Service Bulletin

SB 81440-XX-34-14

SUBJECT: 2101 I/O Approach and 2101 I/O Approach Plus GPS Navigation System, Part numbers 81440-XX-XXXX

Figure 3 80212-11

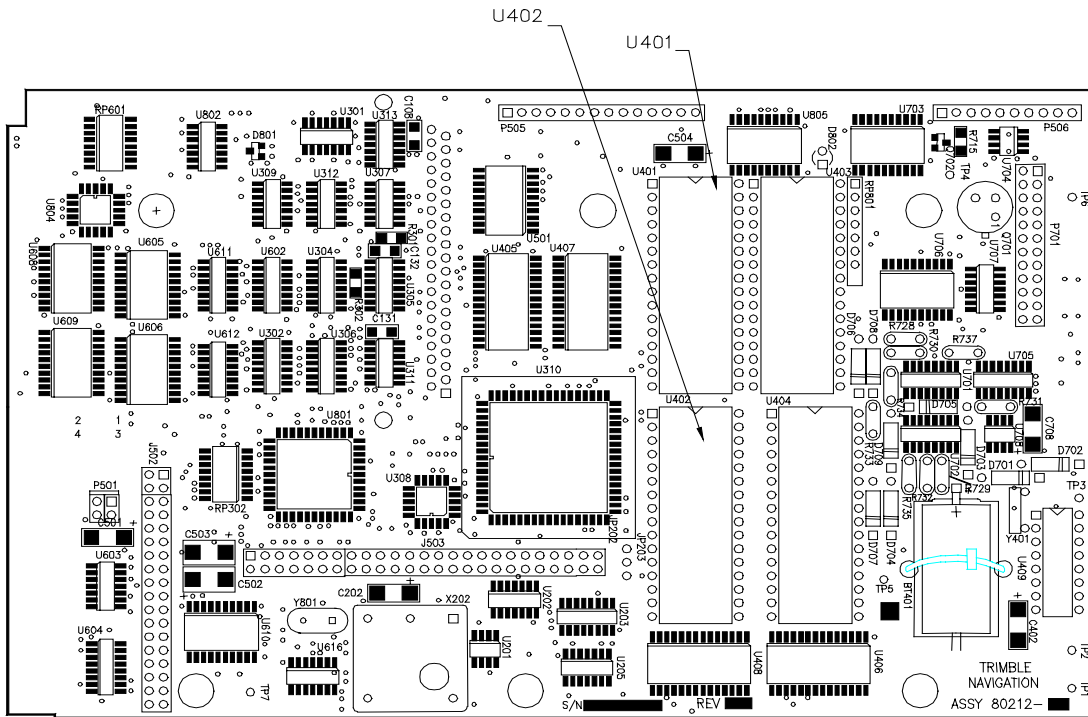
To replace the existing Processor Board (A6) CCA with a modified CCA, so unit will be capable of addressing a 4 MB database.

1. Remove old IOP CCA, PN 80212-XX. Return FFS for credit.
2. Install new IOP CCA, P/N 80212-11 (Figure 5).

Figure 4 82875-01-A

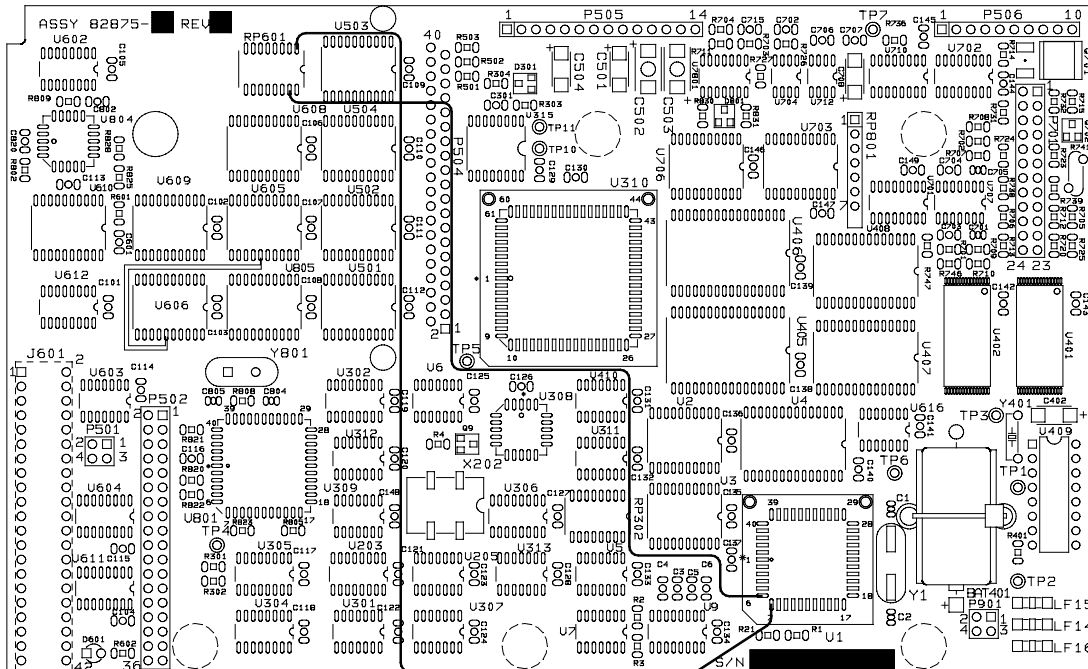
1. Remove old IOP CCA, PN 82875-XX-A. Return to FFS for credit.
2. Install new IOP CCA, PN 82875-01-A (Figure 6).
